Work Order ID 112544

Work Order ID: 112544
Parent Item: D350-689-013
Parent Item Name: Floor Provisions

DART SERVICE INSTRUCTION
TO AMEND INSTALLATION INSTRUCTIONS IIN-D350-689 REV. B
AND INSTRUCTIONS FOR CONTINUED AIRWORTHINESS ICA-D350-689 REV. 1
REF. TCCA STC: SH02-33
REF. FAA STC: SR01620NY
REF. EASA STC: EASA.IM.R.S.01453
REF. TCA STC: 2005S03-09

B	CHANGES TO -013 KIT INSTALLATION. REF: CIR12-12.	MB	12.11.09
A	NEW ISSUE	MB	11.12.22
REV.	DESCRIPTION	BY	DATE
DESIGN		DART AEROSPACE LTD	
DRAWN		HAWKESBURY, ONTARIO, CANADA	
CHECKED		DRAWING NO.	REV. B
MFG. APPR.	N/A	DSI 9588	SHEET 1 OF 6
APPROVED		TITLE	SCALE
DE APPR.		INSTALLATION CHANGE	NTS
DATE	12.11.09	COPYRIGHT © 2011 BY DART AEROSPACE LTD THIS DOCUMENT IS PRIVATE AND CONFIDENTIAL AND IS SUPPLIED ON THE EXPRESS CONDITION THAT IT IS NOT TO BE USED FOR ANY PURPOSE OR COPIED OR COMMUNICATED TO ANY OTHER PERSON WITHOUT WRITTEN PERMISSION FROM DART AEROSPACE LTD.

FIGURE 1: UPDATES TO CROSS SECTIONS F-F AND M-M
 With reference to Figures 5 and 7 of IIN-D350-689
 (Figures 25-5 and 25-7 of ICA-D350-689)

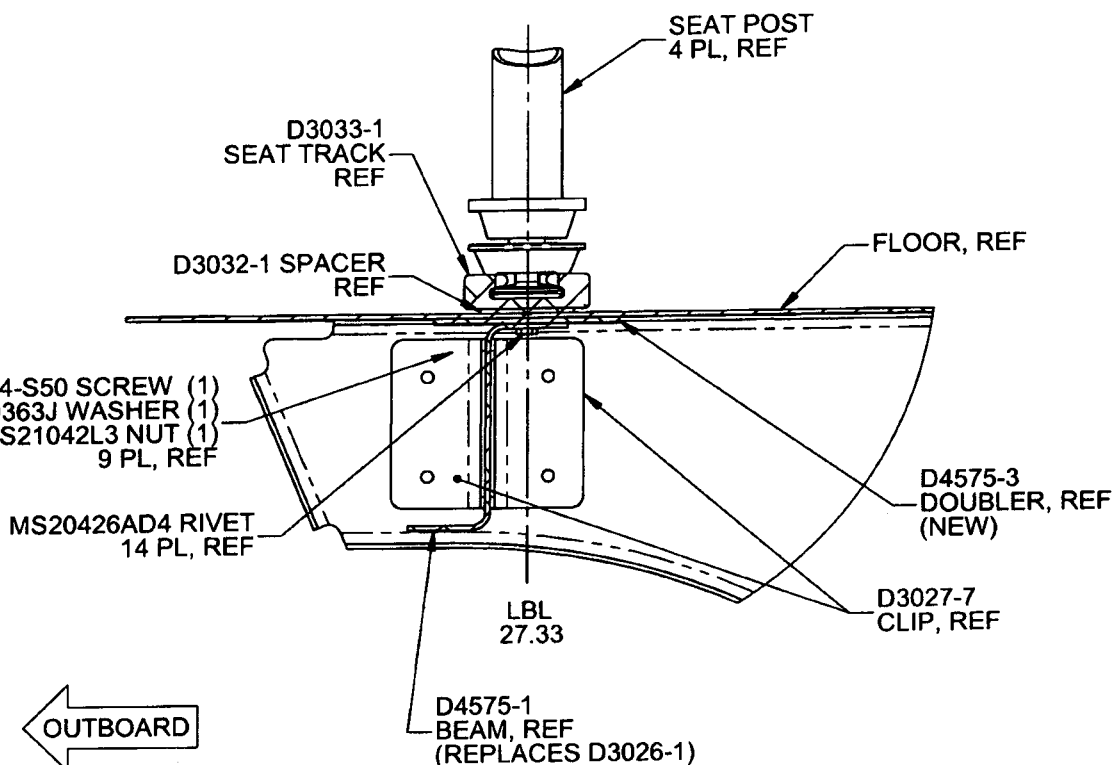
If there is an existing stringer at LBL 27.33, it will need to be removed from that location. Locate D4575-1 Beam, D4575-3 Doubler, and D3032-1 Spacer as shown in Figure 1 of this Service Instruction. Transfer drill existing holes from the aircraft floor to the D4575-1 Beam, D4575-3 Doubler, and D3032-1 Spacer. Ensure 1.0" to 1.5" rivet pitch and add additional holes if required. If there is no existing stringer, locate D4575-1 Beam, D4575-3 Doubler, and D3032-1 Spacer as shown in Figure 1 of this Service Instruction and drill Ø0.128" holes on a 1.0" to 1.5" pitch.

Counter sink holes in the D3032-1 Spacer for MS20426AD4 rivets. Install D4575-1 Beam, D4575-3 Doubler, and D3032-1 Spacer to floor using MS20426AD4 rivets.

FIGURE 2: UPDATES TO FIGURE 21 (IIN-D350-689) AND 25-21 (ICA-D350-689)
 With reference to Figures 19 and 20 of IIN-D350-689
 (Figures 25-19 and 25-20 of ICA-D350-689)

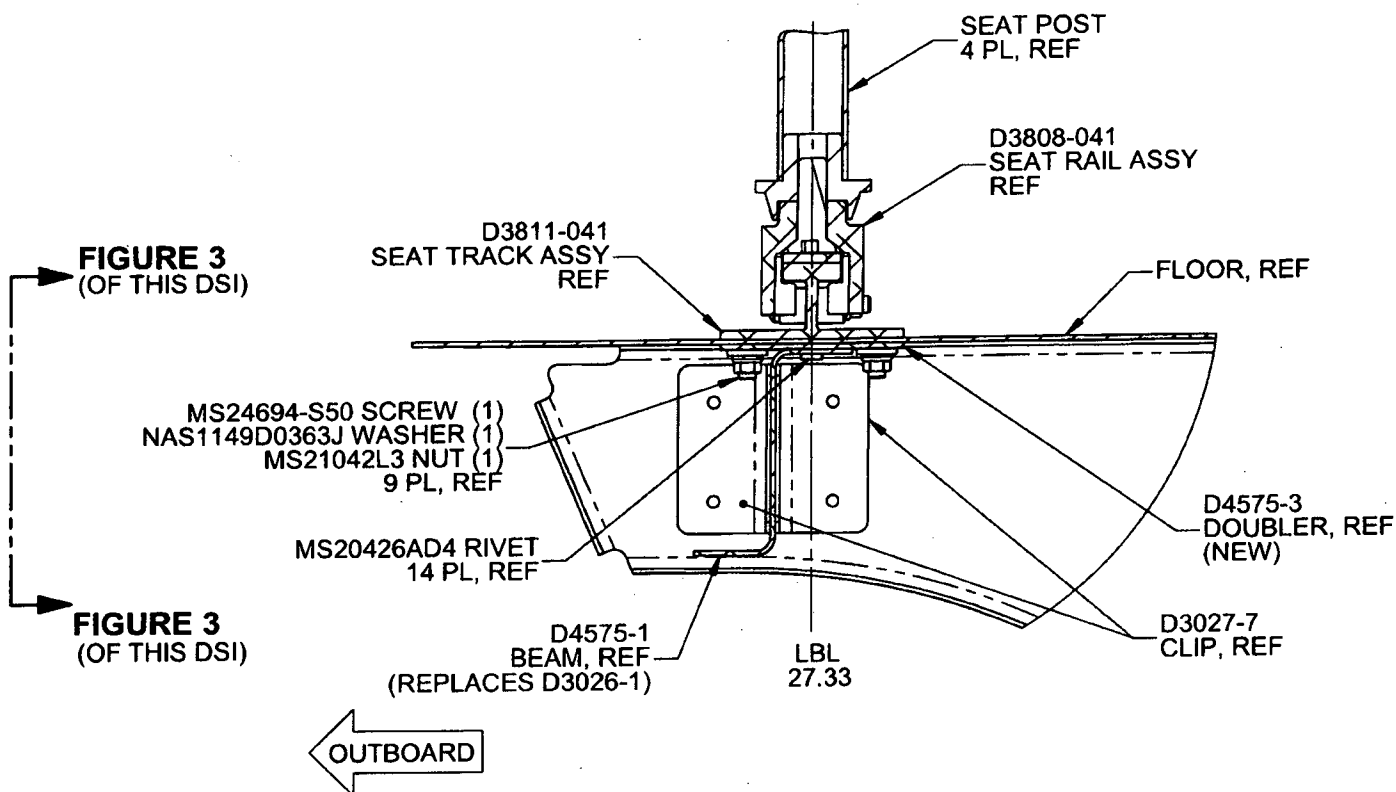
If there is an existing stringer at LBL 27.33, it will need to be removed from that location. Locate D4575-1 Beam and D4575-3 Doubler as shown in Figure 2 of this Service Instruction. Transfer drill existing holes from the aircraft floor to the D4575-1 Beam and D4575-3 Doubler. Ensure 1.0" to 1.5" rivet pitch and add additional holes if required. If there is no existing stringer, locate D4575-1 Beam and D4575-3 Doubler as shown in Figure 1 of this Service Instruction and drill Ø0.128" holes on a 1.0" to 1.5" pitch.

Attach D4575-1 Beam and D4575-3 Doubler to floor using qty (14) MS20426AD4 rivets.

FIGURE 3: RELIEFS ON D4575-1/-3
(ONLY D4575-1/-3 SHOWN FOR CLARITY)
VIEW LOOKING INBOARD

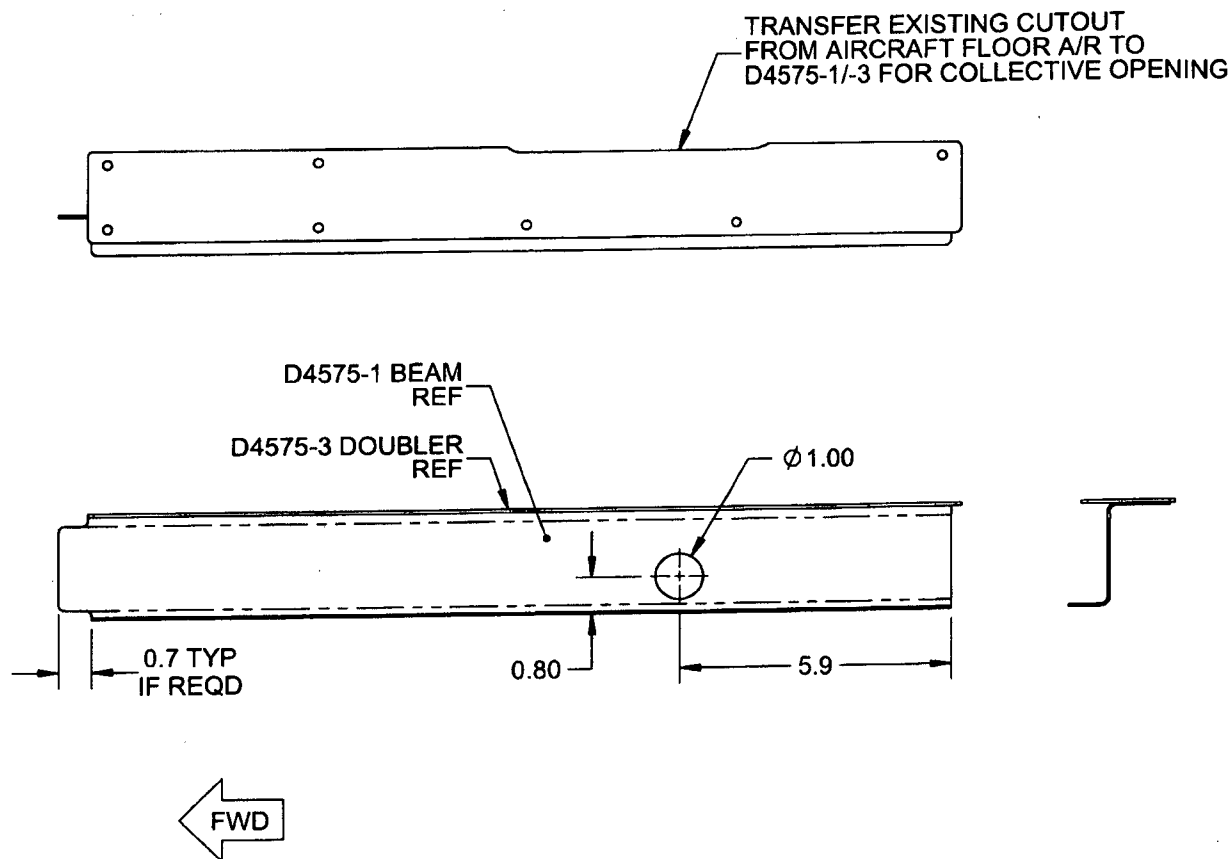
Note: Drill a Ø1.00" (Ø25.4 mm) hole in the D4575-1 Beam to clear extension tube of collective and cutout as required for clearance of collective opening and fwd bulkhead as shown in Figure 3 of this Service Instruction.

Note: Drill a Ø1.00" (Ø25.4 mm) hole in the D4575-1 Beam to clear extension tube of collective and cutout as required for clearance of collective opening and fwd bulkhead as shown in Figure 3 of this Service Instruction.
